Le Hamel
War Memorial
FRANCE

Re: Condition of the Australian Monument at Le Hamel.

**Australian National Memorial
Le Hamel**

Photo 0341

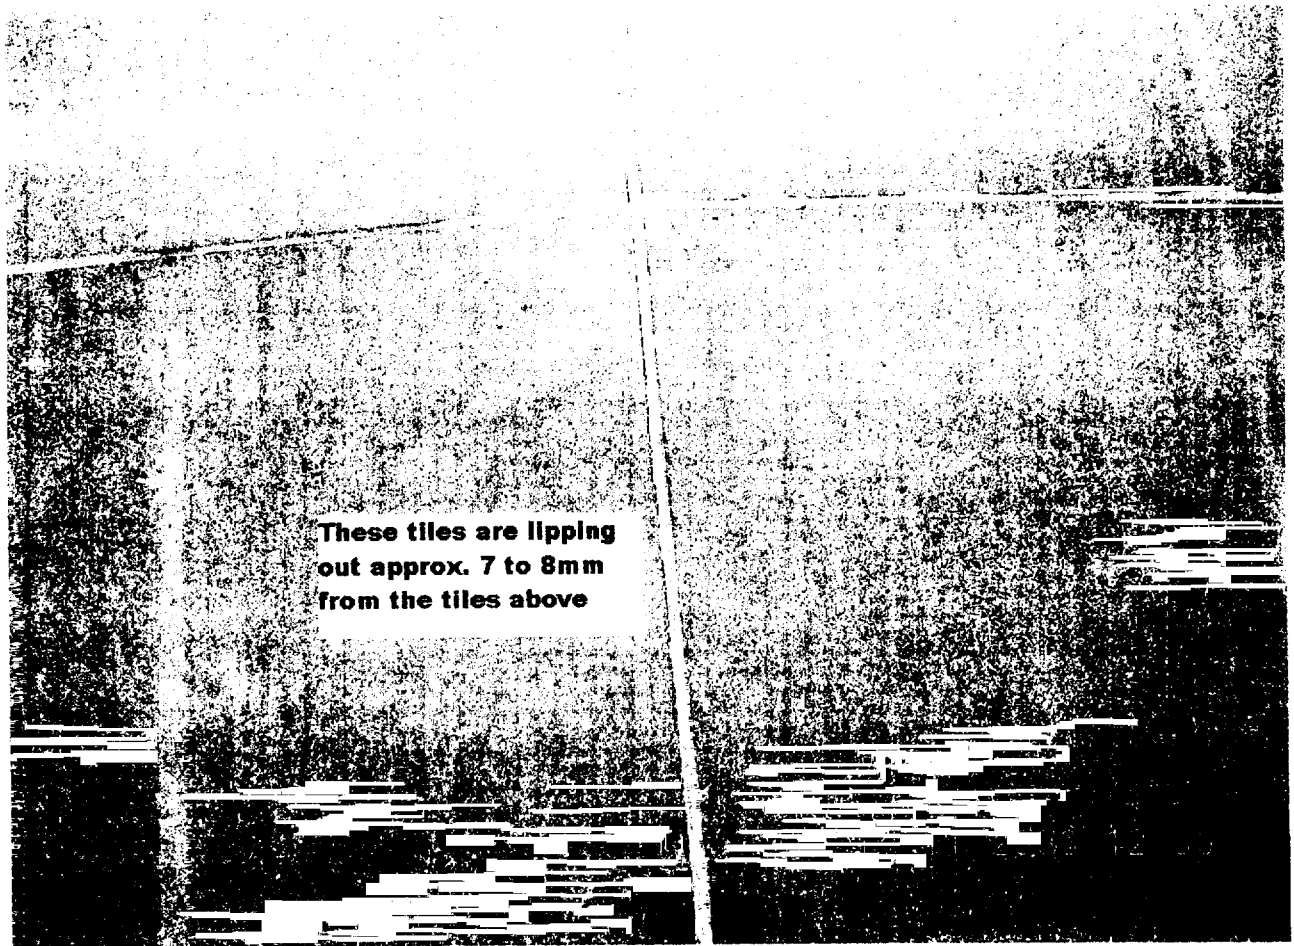
There exists a joint of approximately 3mm around each tile but due to tolerances this joint varies down to 1.5mm & up to 5mm in some areas. The joint is filled with silicon mastic either black or clear in colour. There is no provision for any expansion anywhere in the granite cladding and it is obvious that the joint space allowed is not sufficient to accommodate the thermal movements that occur. (see photos 0341, 0342, 0343, 0339 attached).

This is particularly evident on the outer face of the monument as the radius is such that the tiles would almost touch when not back relieved and in fact the tiles have moved off the wall significantly in places (see photo 0341 attached). The tiles are only staying in place because they are 'locked together' by the joint spaces filling with foreign material and some of the tiles can be pushed back into the wall and then spring back out. This is extremely dangerous and unstable. The tiles higher up on the monument show signs of sagging without the support of the tiles beneath. If the lower tiles actually fall out, the tiles above will be put under more stress.
